| SULZER                                |                      | CONFIDENTIAL                                                                                                                                                                                                                                                                                                                                                                                                                                                                                                                          |                                                                                                        |
| Pump tag / item No.                   | 18-P-1812            | Last Modification Date

| 422701-003                                |  | 422701-003                     |  |

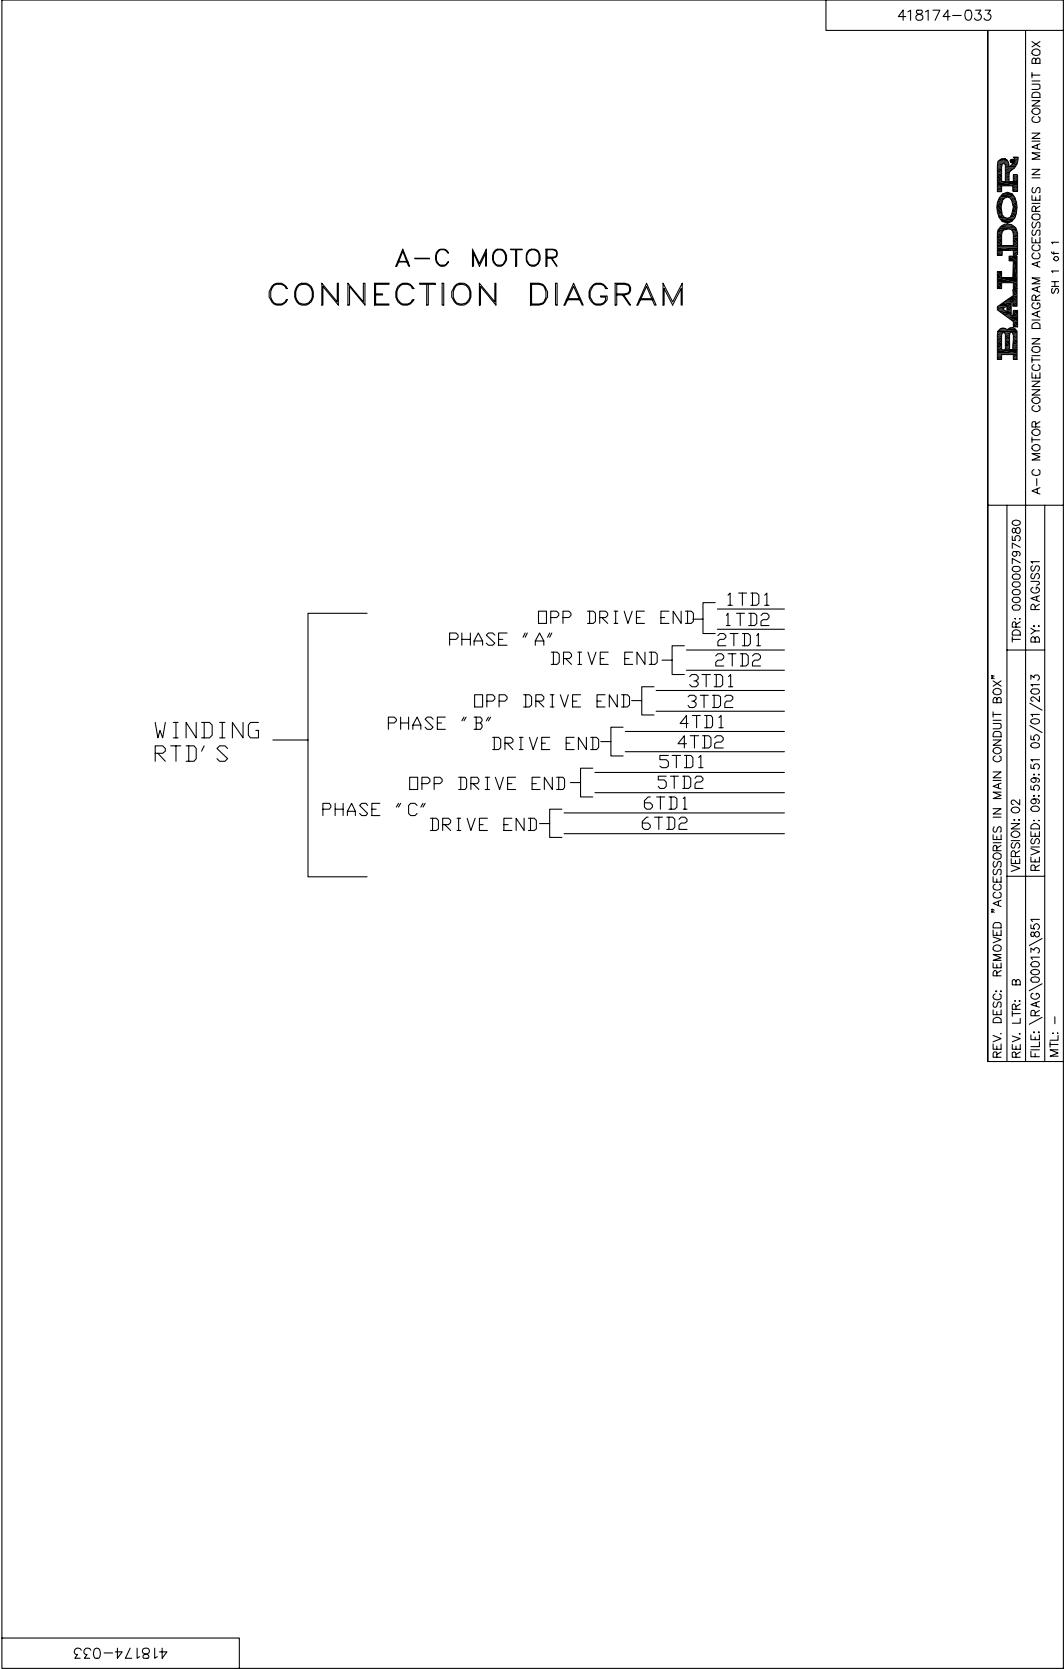
| SULZER                                |                      | CONFIDENTIAL                                                                                                                                                                                                                                                                                                                                                                                                                                                                                                                          |                                                                                                        |
|---------------------------------------|----------------------|---------------------------------------------------------------------------------------------------------------------------------------------------------------------------------------------------------------------------------------------------------------------------------------------------------------------------------------------------------------------------------------------------------------------------------------------------------------------------------------------------------------------------------------|--------------------------------------------------------------------------------------------------------|
| 1                                     | REV 4                | <div><div>WINDING<br/>RTD'S</div><div><div>OPP DRIVE END-1TD1<br/>                  1TD2<br/>PHASE "A" DRIVE END-2TD1<br/>                  2TD2<br/>OPP DRIVE END-3TD1<br/>                  3TD2<br/>PHASE "B" DRIVE END-4TD1<br/>                  4TD2<br/>OPP DRIVE END-5TD1<br/>                  5TD2<br/>PHASE "C" DRIVE END-6TD1<br/>                  6TD2</div></div><div>Winding RTD's are not applicable for LV motors as per project requirement. Vendor to clarify from where this requirement is arrived.</div></div> | RDT's was included by configuration mistake but this does'nt have any impact in yhe motor performance. |
